# Site Accessibility Evaluation

### **Widefield Park**

**Accessibility Evaluation**

***Inspection Date: 06/26/2018***

Finding 174005 Main Photo

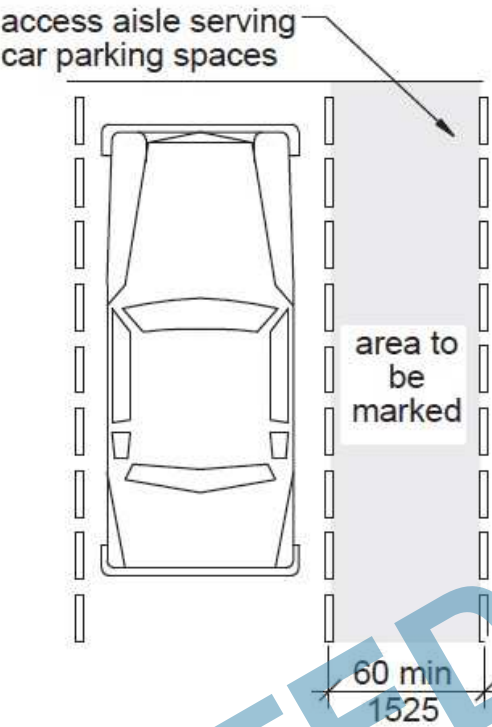
The access aisle is missing at the accessible parking stall.

No accessible aisle

Stripe access aisle in between 2 accessible parking stalls.

Finding 174006 Main Photo

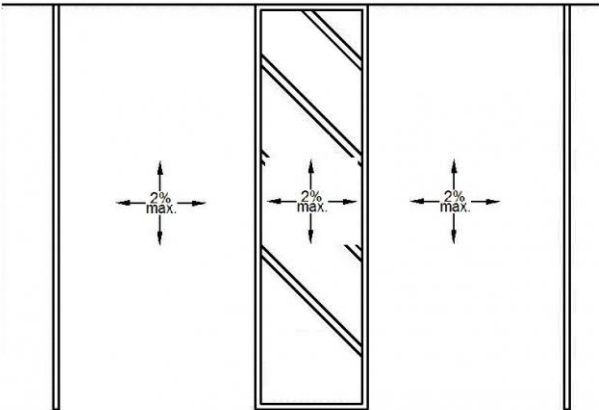
The access aisle for the accessible parking stall contains a built up curb ramp which results in significant slopes greater than 2 percent.

No curb ramp into accessible route

Remove existing curb ramp and build new curb ramp in line with new access aisle to meet 2010 ADA standards.

Finding 174007 Main Photo

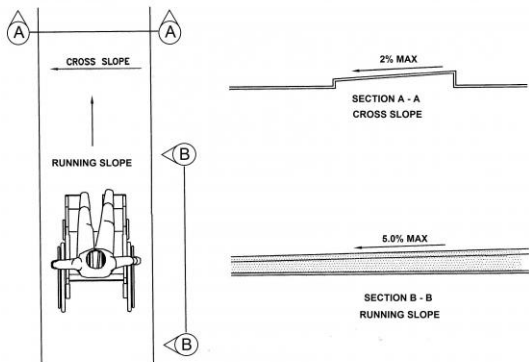
The accessible route between the public bathrooms entrances and the accessible parking on the site contains running slopes greater than 5% and has not been constructed as a ramp (i.e. handrails, wheel guides, etc.).

Certain sections of circulation path up to 8.66% running slope 50ft from parking lot sidewalk

Level path of travel to 5% maximum to meet current ADA standards.

Finding 174008 Main Photo

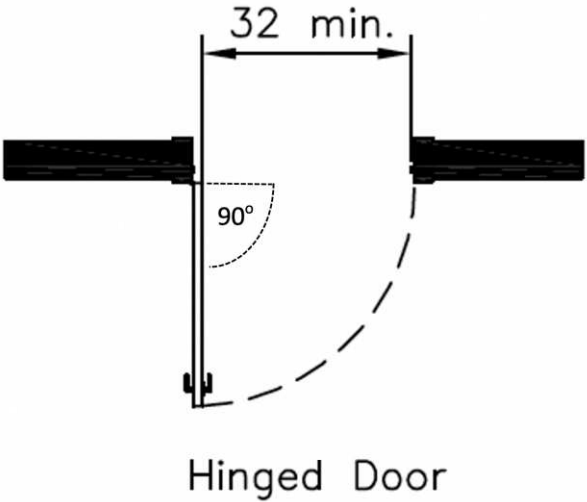
The door opening does not provide at least 32 inches between the face of the door and the opposite stop.

29 inches opening  
width

Reconfigure door opening to meet compliance. Due to the existing and type of structure, it may be structurally infeasible.

Finding 174086 Main Photo

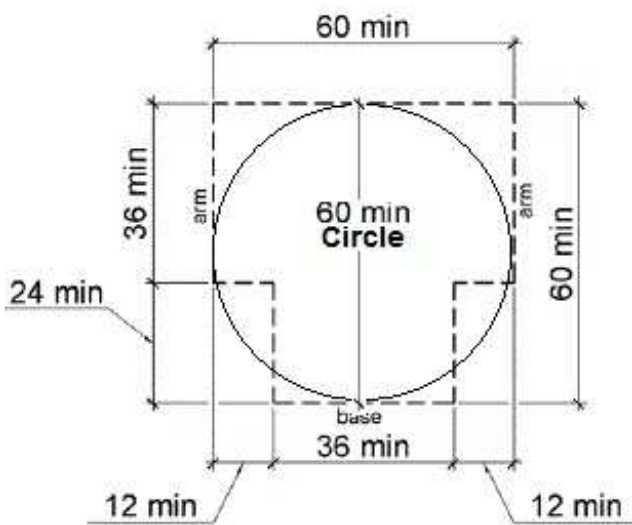
Compliant turning space has not been provided.

54 inches in diameter

Alter toilet, urinal and lavatory to ensure a 60 inch radius is provided.

Finding 174144 Main Photo

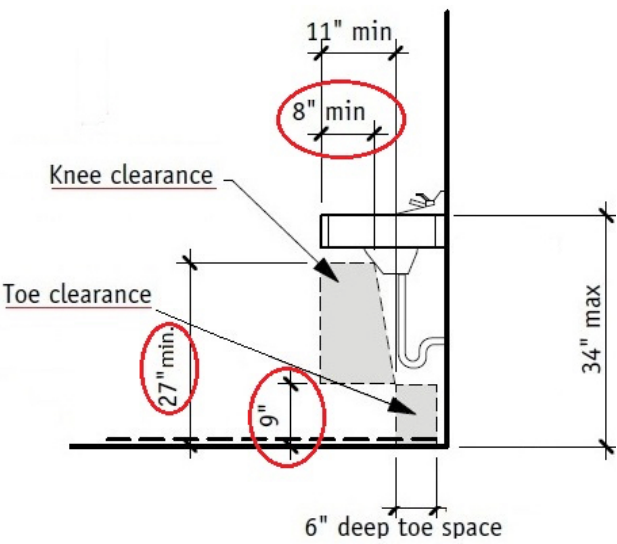
The apron at the sink projects too low to the floor.

Measures only 4 inches back from the front edge

Replace lavatory with one that provides a minimum height from the bottom edge of no less than 27 inches above finished floor and 8 inches minimum in depth for knee clearance.

Finding 174163 Main Photo

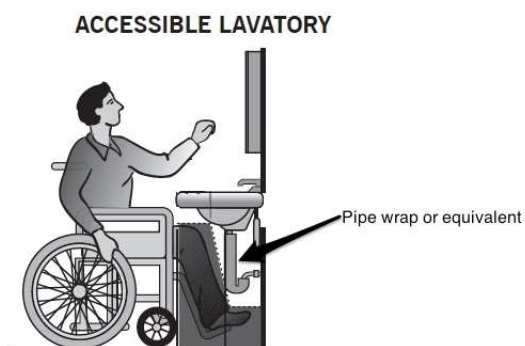
The water and drain pipes under the lavatory are not adequately insulated.

Drain pipes not insulated

Insulate drain pipes underneath lavatory.

Finding 174549 Main Photo

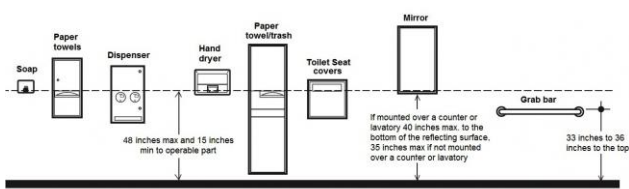
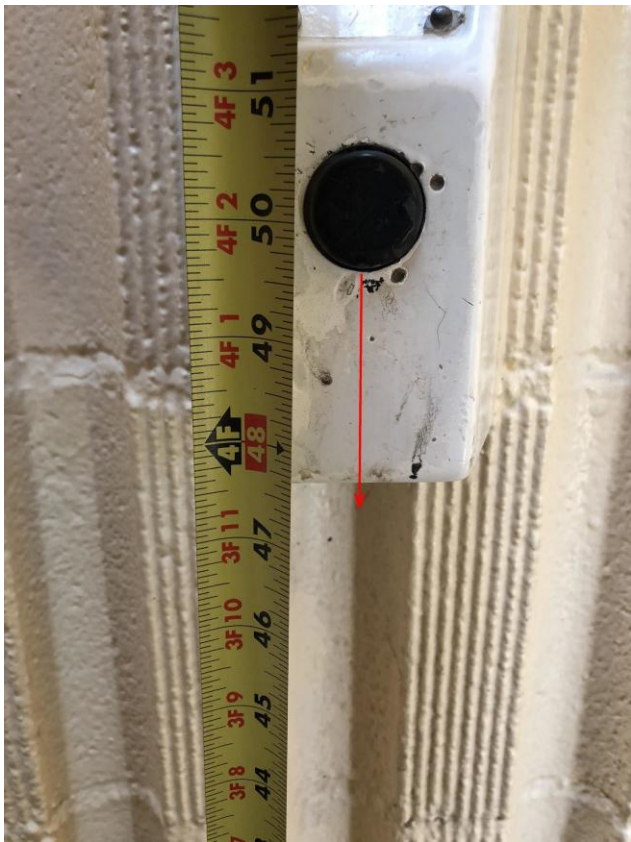
The hand dryer dispenser's operation mechanism is too high off the floor.

50.5 inches from the ground

Lower hand dryer 3 to 4 inches to meet compliance. 48 inches maximum height above finished floor for operable parts (sensor).

Finding 174559 Main Photo

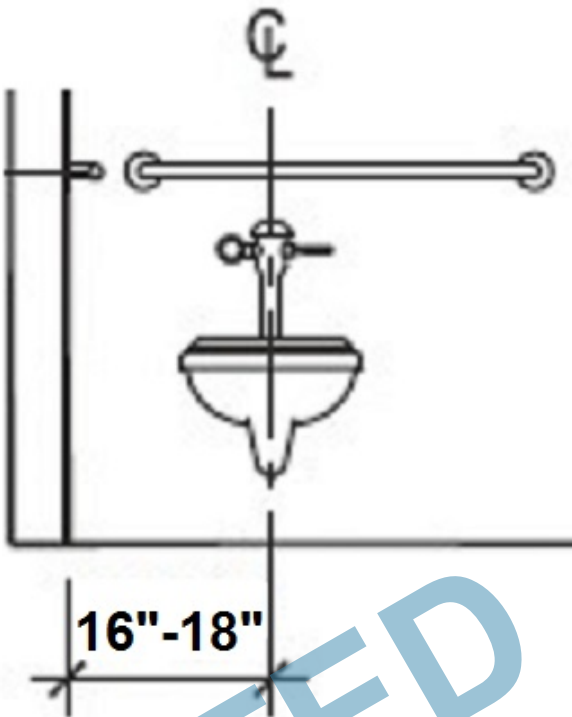
The toilet is not located within the range allowed from the side wall or partition.

18.5 inches from side wall

Re-position toilet between 16 inches minimum and 18 inches maximum from centerline of toilet to side wall. May require plumbing alteration.

Finding 174571 Main Photo

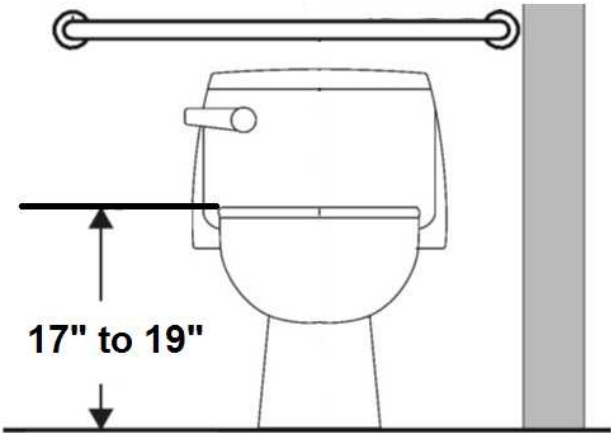
The toilet seat is not located within the range allowed off the floor.

15 inches

Adjust toilet height, replace toilet or replace toilet seat with one that will meet the minimum height of 17 inches but no more than maximum height of 19 inches.

Finding 174578 Main Photo

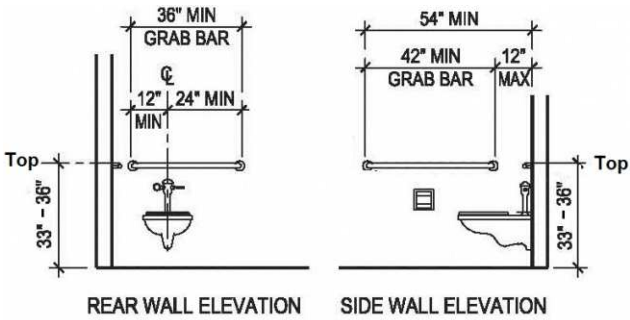
Accessible toilets must have grab bars installed.

Missing grab bars

Install 1 side and 1 rear grab bar at 36 inches maximum above finished floor measured to the top of the gripping surface. Please see finding details for compliant measurements.

Finding 174582 Main Photo

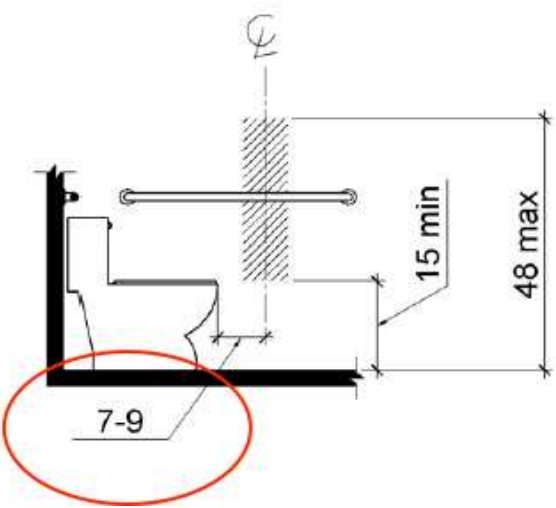
The toilet paper is not installed within the compliant range.

Rear wall

Relocate and ensure toilet paper dispenser is between 7 inches minimum to 9 inches maximum in front of water closet measured to centerline of the dispenser. If toilet paper dispenser is installed above side grab bar ensure there is 12 inches of clearance minimum above side grab bar but no more than 48 inches in height measured from the floor to the center of the paper roll. If installed below grab bar ensure there is 1.5 inches clearance minimum but no less than 15 inches in height measured from the floor to the center of the paper roll.
